TECHNICAL BULLETIN: 15-07

DATE: June 4, 2015

SUBJECT: Release of Software Version 4.0 with Windows CE 6.0 operating system for ARGO 7, FT5300, RL5300, RT2300, and RL2300 with 8" and 10.4 display.

1. Initial Configuration Screen

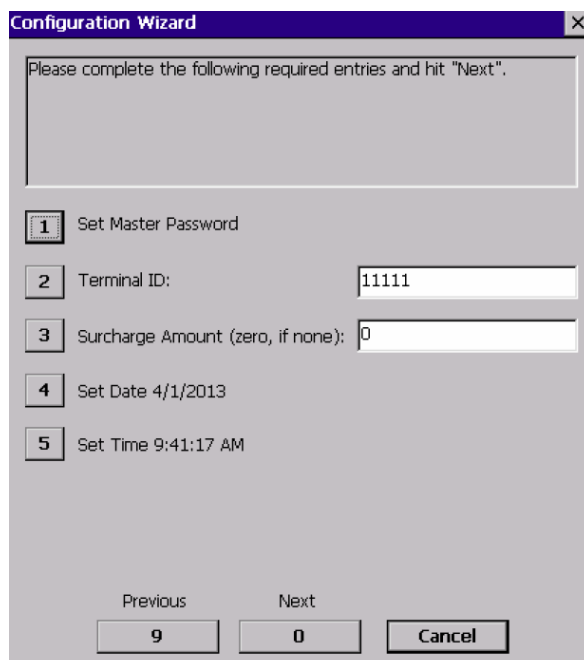
- **Configuration Wizard**

This software release contains a wizard type interface to step customers through the initial ATM Setup. The wizard includes the following steps:
